KWM-380 TRANSCEIVER (622-5093-101)
HF-380 TRANSCEIVER (622-3580-101)
RECEIVER-EXCITER CIRCUIT CARD A3 (638-6908-001)

SERVICE BULLETIN NO 1**PRODUCT IMPROVEMENT**

This is a nonmandatory service bulletin which applies to the following:

P/O Receiver-Exciter Assembly A3,
Schematic Diagram
Figure 3

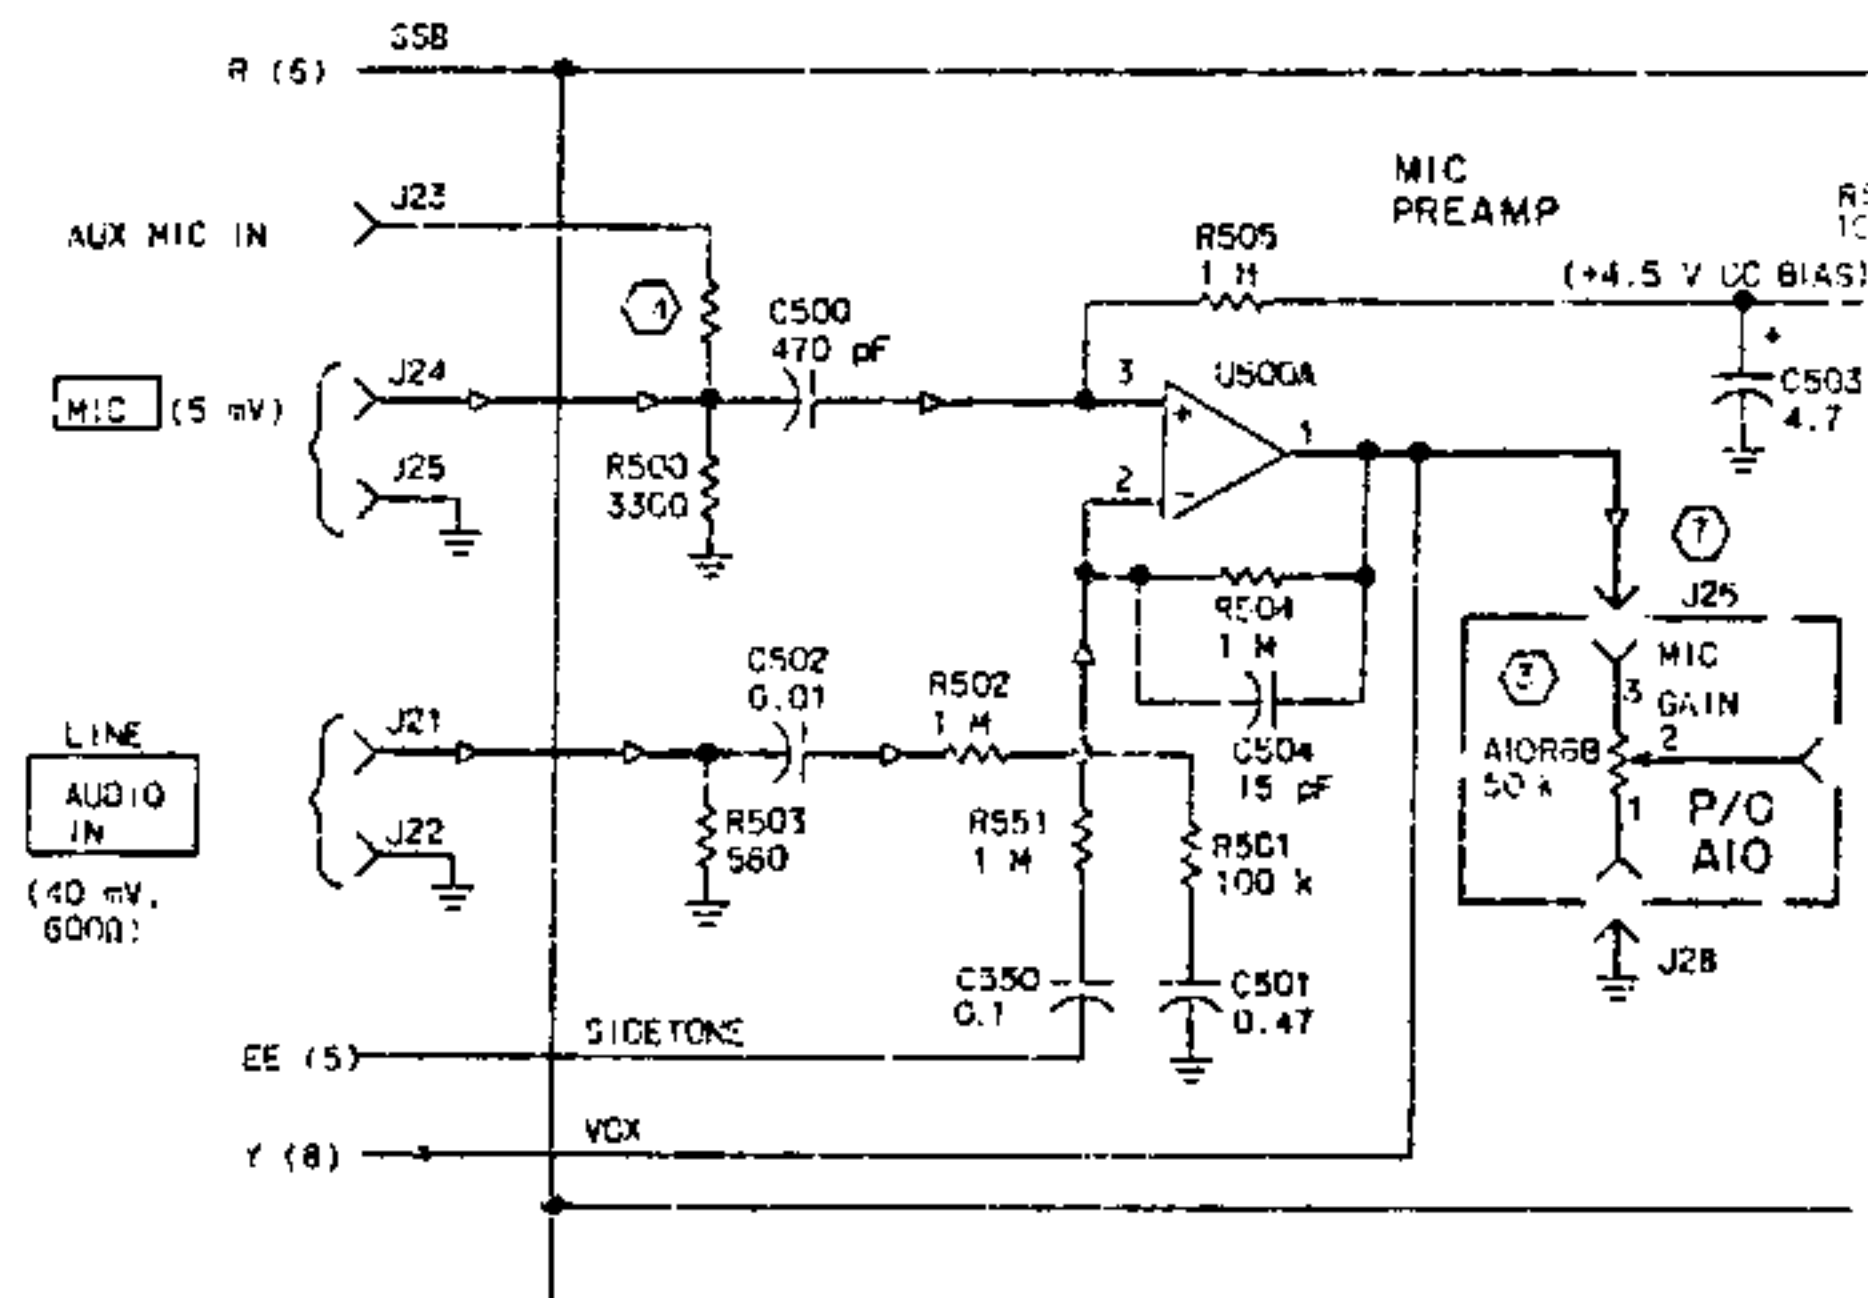
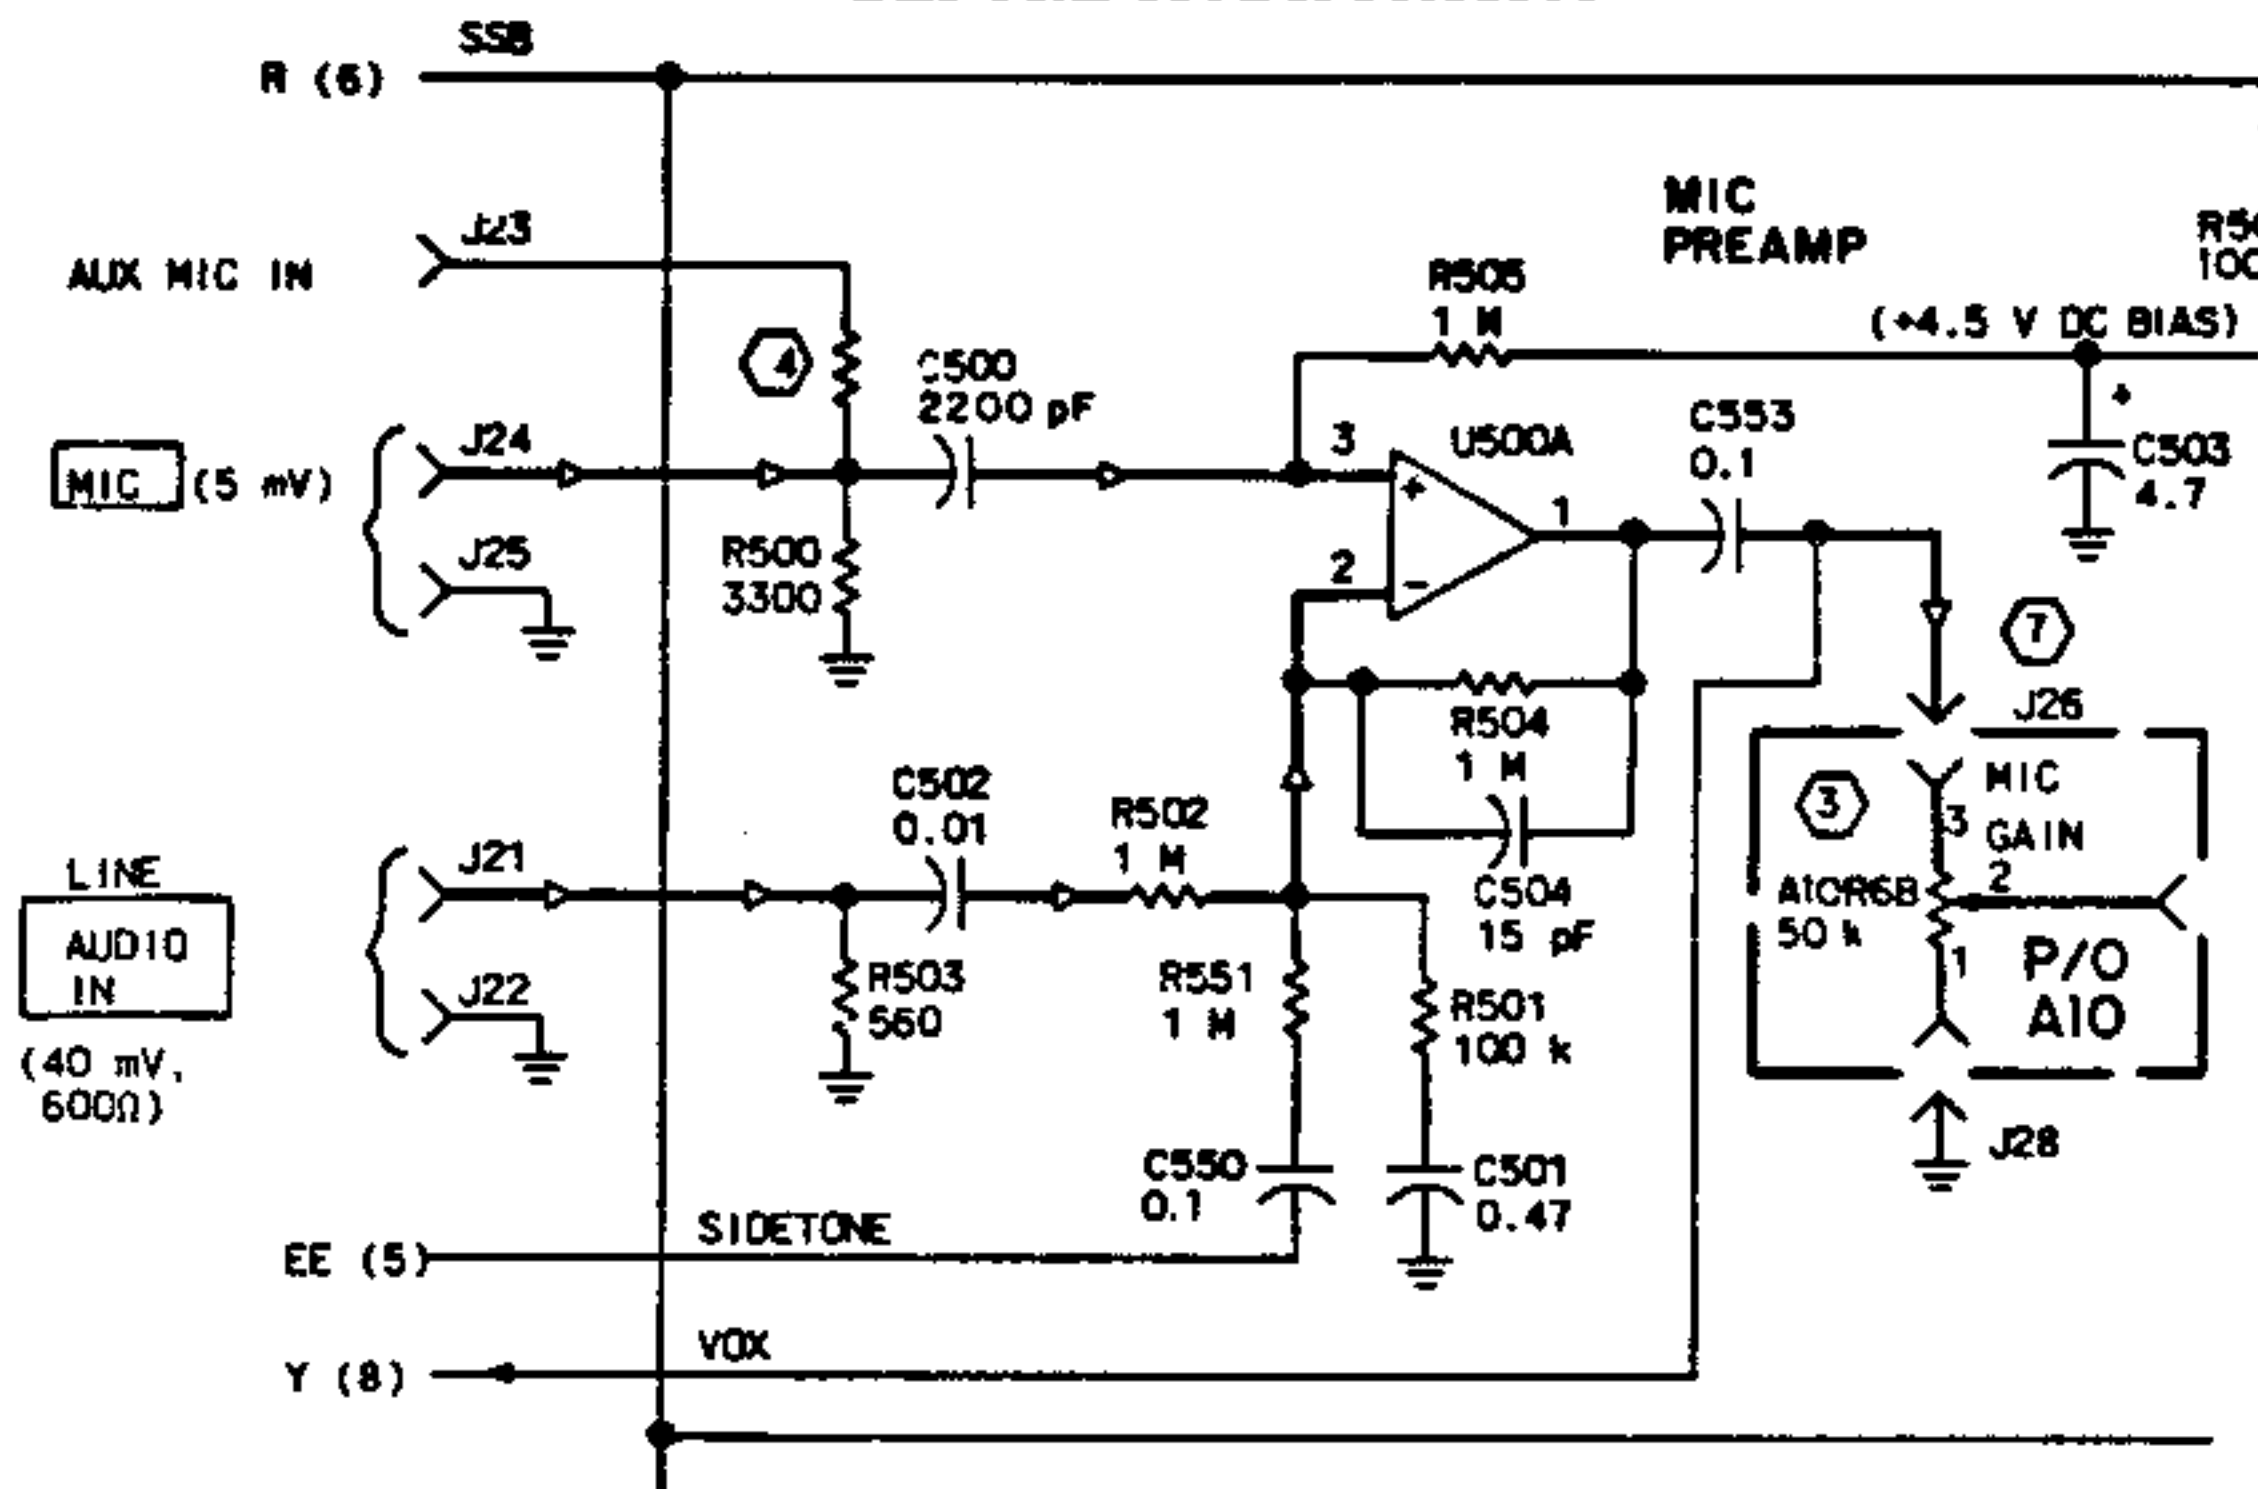
NOTE: Refer to figure 2 while performing steps F through H. Capacitor C553 is part of receiver-exciter assembly A3 but is mounted on front panel assembly A10. If C553 were mounted on the A3 card, a circuit trace cut on the bottom of the card would be required making it necessary to remove the card from the radio. Refer to figure 3 for a schematic diagram which shows the location of C553.

Directional Coupler/TR Relay A2A2
Figure 1

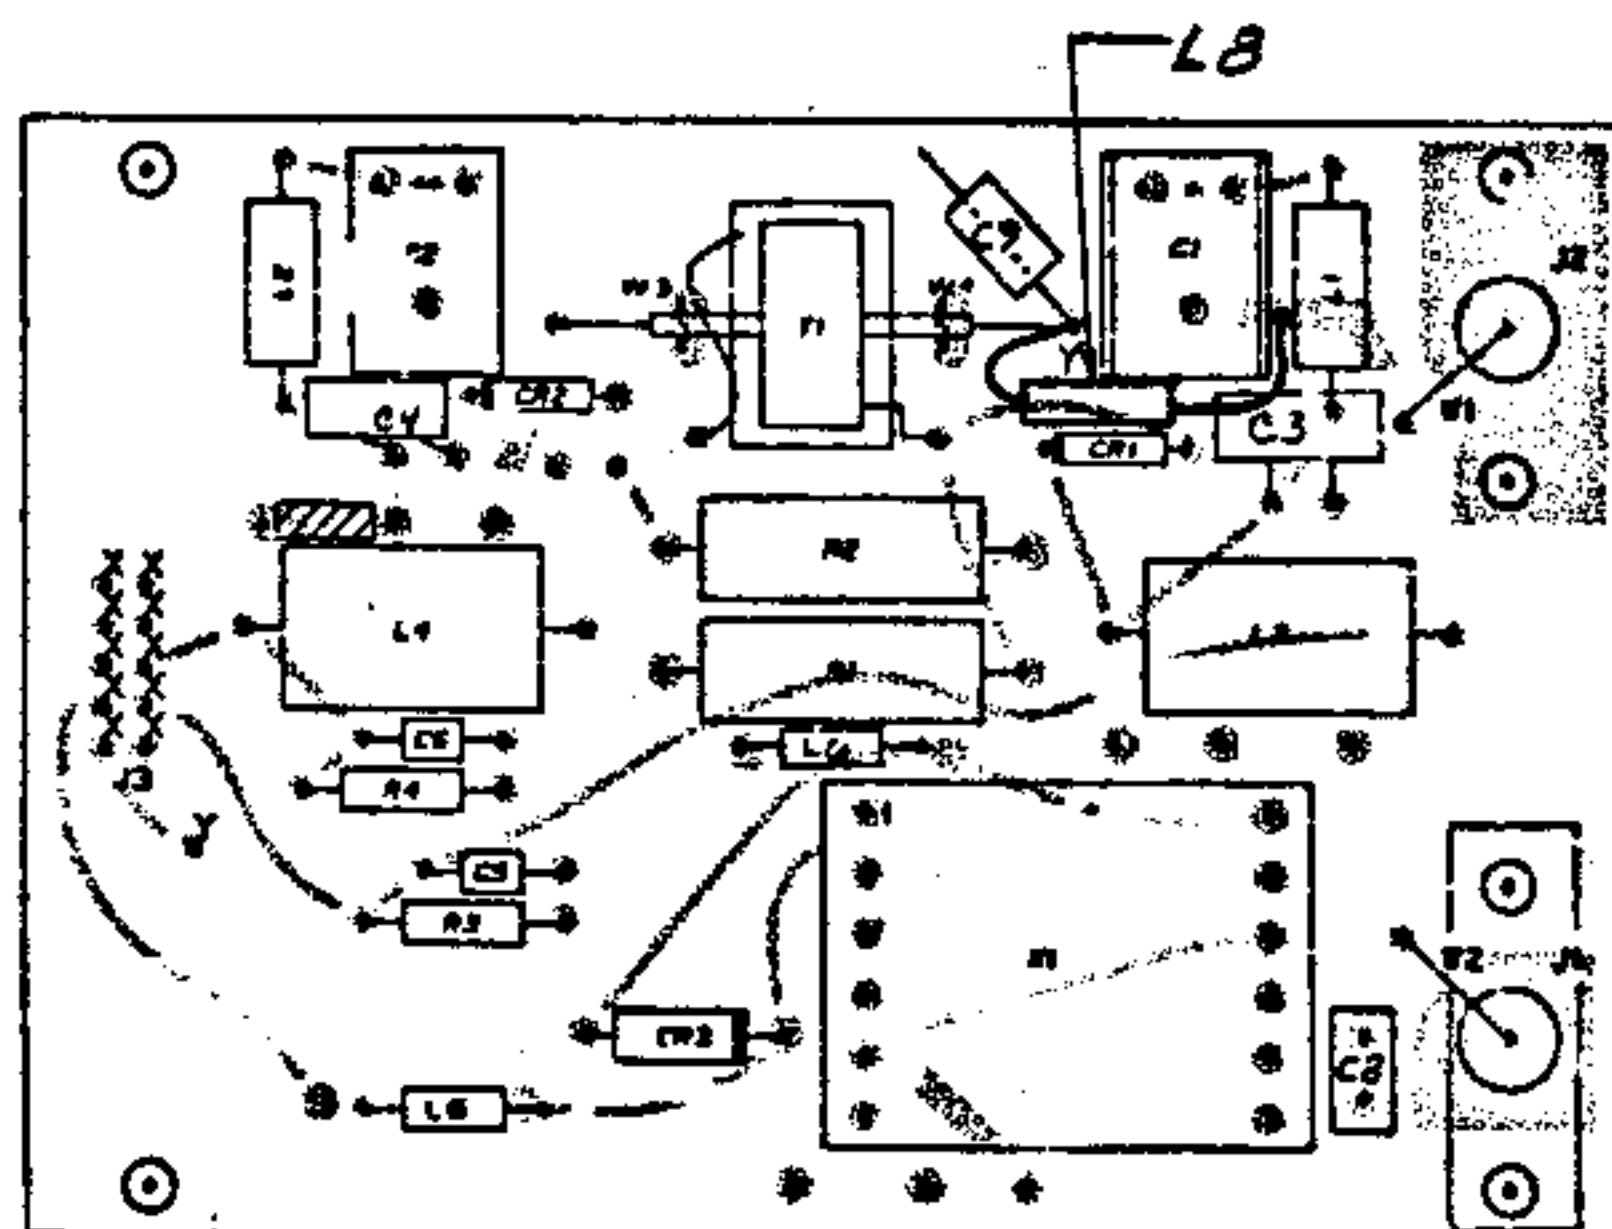
- F. Refer to figure 1. Install 220- μ H choke L8 (240-2524-000) as follows:
